# TECHNICAL BULLETIN

214ST-95-142

**MODEL AFFECTED:** 214ST

**SUBJECT:** SCISSORS AND SLEEVE ASSEMBLY, P/N 214-010-501-103, -107, -109 -113 AND -115, DRIVE PLATE ATTACHMENT BOLT AND WASHER REPLACEMENT

**FIGURE 1**

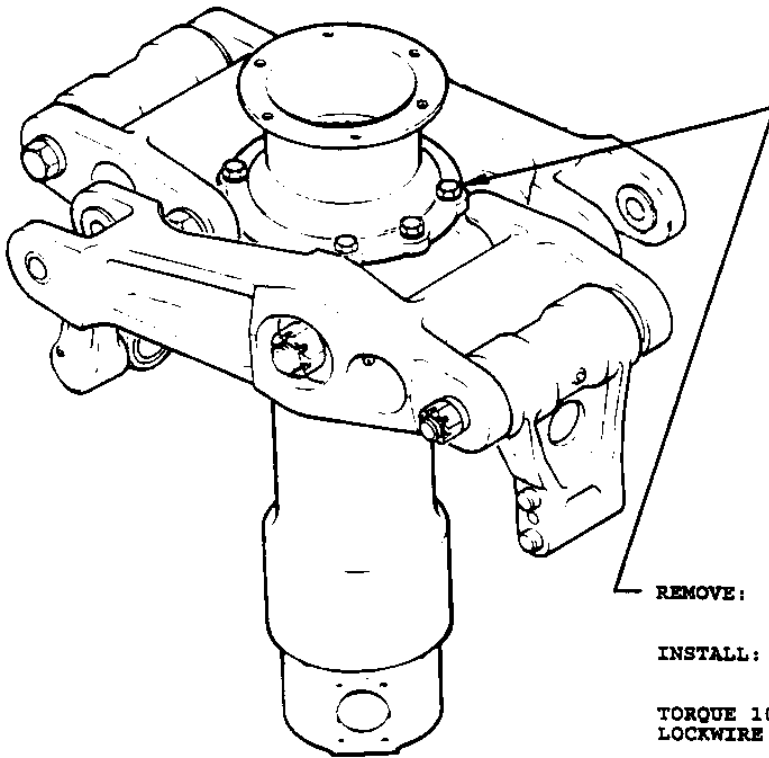
**REMOVE:** 6 P/N NAS1305-3H OR NAS6605H3 BOLTS  
6 P/N AN960-516 WASHERS

**INSTALL:** 6 P/N 20-097D05H5 BOLTS  
6 P/N 140-007-21S18D6 WASHERS

**TORQUE 100 TO 140 INCH POUNDS**  
**LOCKWIRE WITH MS20995C32**

1. Accomplish the 250 hours scissors and sleeve drive plate spline inspection in accordance with the Model 214ST Maintenance Manual, Chapter 62.
  - a. Remove and discard the six (6) drive plate bolts P/N NAS1305-3H or P/N NAS6605H3, and washers P/N AN960-516.
  - b. Install six (6) new bolts P/N 20-097D05H5 and washers P/N 140-007-21S18D6. Torque bolts 100 to 140 inch pounds and secure with lockwire MS20995C32.

P/N NAS1305-3H or NAS6605H3 and P/N AN960-516 washers may not be intermixed with P/N 20-097D05H5 bolts and P/N 140-007-21S18D6 washers.
